CORPORATE PRODUCT APPROVALS

October 5, 1987

Enclosed are the frame ground .187 male and female connector drawings as promised in my 6/19/87 letter to add to the ESDI document X3T9.3/87-005, Drawing #5-7, J4/P4.

X3T9.2/87-170

Fig. 5-1A: J1 Header Connector

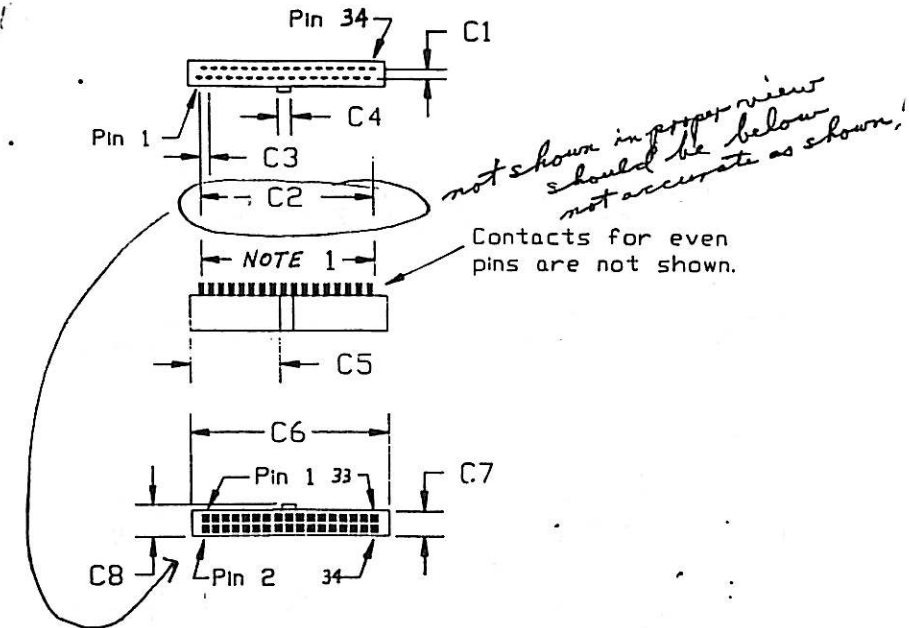
Also enclosed are the 20 & 34 flat ribbon center polarized cable connectors, P1 & P2. Either the use of these drawings or the drawings submitted by Harvey Waltersdorf 9/11/87 (attachment #2 & #3) could be accepted by the committee with exception of his Fig. 5-1A: J1 header connector dimension D4. That dimension should be .336 for the 20 pin and 34 pin columns. And on Fig. 5-1B: P1 Receptacle connector, C2 dimension should be moved to the lower connector drawing to show a more proper view of C2 dimension.
